Remarks

Richard D. Fuerle
1711 West River Road
Grand Island, NY 14072
(716)-774-0091
November 15, 2004
CASE YA03CIP-div

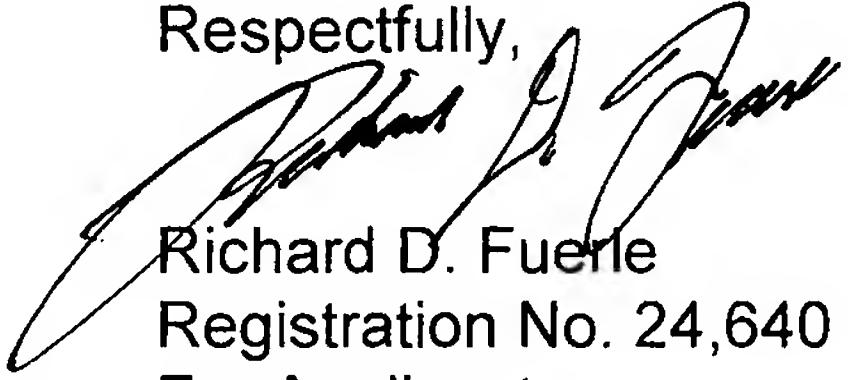
The drawings were objected to under 37 CFR 1.83(a). Applicant herewith encloses new drawings, Figures 21 and 22, which are believed to overcome this objection. Figure 21 shows a P-channel transistor as indicated by the direction of the arrow on the line going from the transistor to the back bias control circuit. Otherwise, Figure 21 is the same as Figure 15. Figure 22 shows "a level voltage shift circuit for shifting the input voltage to said transistor." Figure 22 is a combination of Figure 13 and Figure 15.
